STDC Coastal Structures Monitoring Programme Annual Report 2018-2019

Technical Report 2019-27

Photo 5 Patea groynes (April 2017)

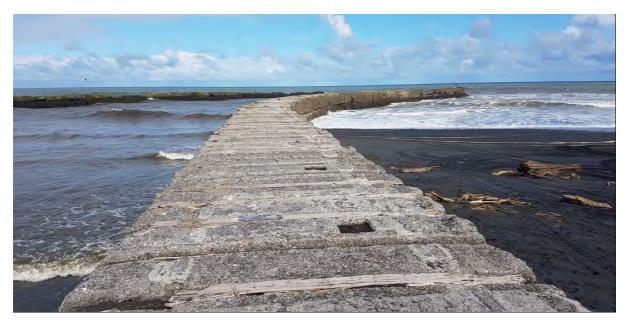
Significant levels of erosion occurred along this coastline during the past 50 years which led to the river moles becoming seriously degraded. Studies undertaken by consultants (Duffill Watts & King, 2006) showed that with the condition of the moles and rate of shoreline change, the river moles could decay, threatening the overall stability of the river entrance. If the stability of the river entrance changed, this could result in the passage between the river and sea becoming no longer navigable. From the studies undertaken by Duffill, Watts & King (2006), it was found that without some intervention process the Patea River would break through behind the southeast mole within 20 to 25 years and prevent navigable access to the sea. It was proposed that the most effective method to maintain a navigable river entrance for small seagoing craft was to reconstruct the southeast seawall. Consent **6839** was granted by the Council authorising the works, which aimed to constrain the river channel to its existing alignment and prevent it from breaking through behind the left mole (Photo 5).
